*in the matter of:* the Resource Management Act 1991

*in the matter of:* a number of applications to take and use water from  
the Upper Waitaki catchment

Addendum to brief of evidence of **Matt Ryan** (on cumulative water quality effects)

**Figure 1: Sensitivity Analysis of Varying Nitrogen Fertiliser Inputs on Nitrogen Leaching from an Irrigated Sheep, Beef and Dairy Farm on Developed Soils**

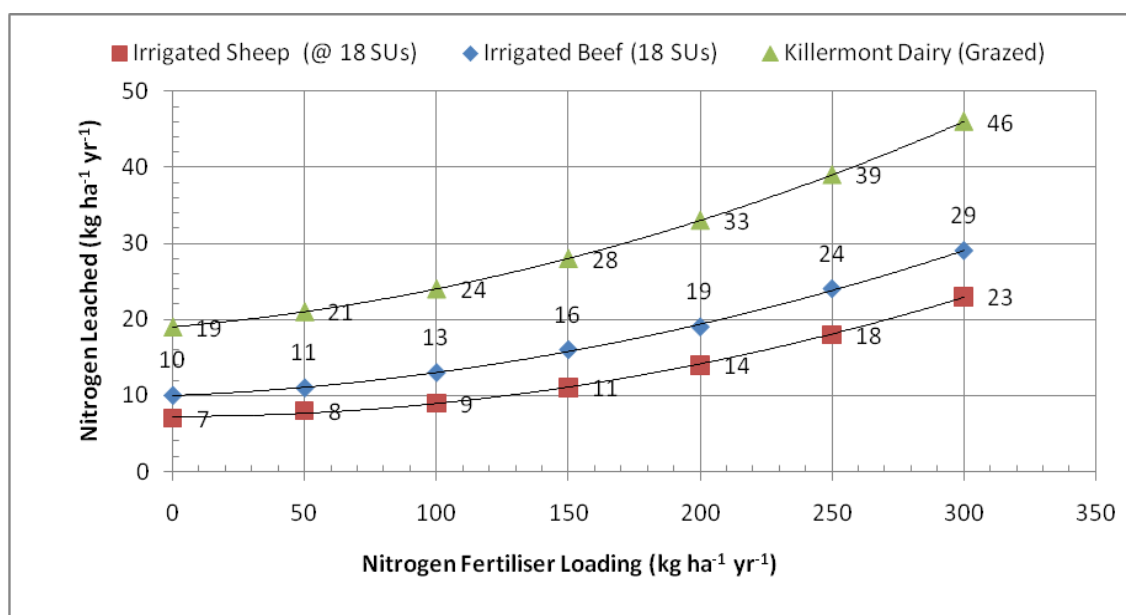
the upper bound nitrogen estimates (from developed soils) likely to have been provided by a sensitivity analysis, I have prepared a simple sensitivity analysis shown in **Figure 1** below which shows the effect of varying nitrogen fertiliser inputs on nitrogen leaching from irrigated blocks from three grazed farming systems under **developed** soils.

- 26 The figure shows that for an irrigated sheep farm, the upper bound leaching estimate would be around 22 kg N/ha/yr, which is in agreement with that reported from research studies (27) in New Zealand that showed nitrogen leaching losses from sheep farms in New Zealand to range from 6 - 66 kg N/ha/yr<sup>5</sup>. Note that for irrigated land grazed solely by beef cattle, the leaching estimate is approaching 30 kg N/ha/yr under high nitrogen fertiliser loadings, which is comparable to the nitrogen leaching estimate (31 kg N/ha/yr) from highly developed soils under Sheep & Beef in the WQS.

- 27 The main conclusion to draw from this exercise is that the nitrogen leaching estimates generated by the OVERSEER model are particularly sensitive to nitrogen fertiliser inputs<sup>1</sup>. Given this, and the fact that no sensitivity analysis has been undertaken in the WQS, and that both **Dr Monaghan** and **Dr Snow** believe that the OVERSEER nitrogen leaching estimates for the light soils in the catchment could be underestimated by up to 20%, I would suggest that a conservative approach is required.
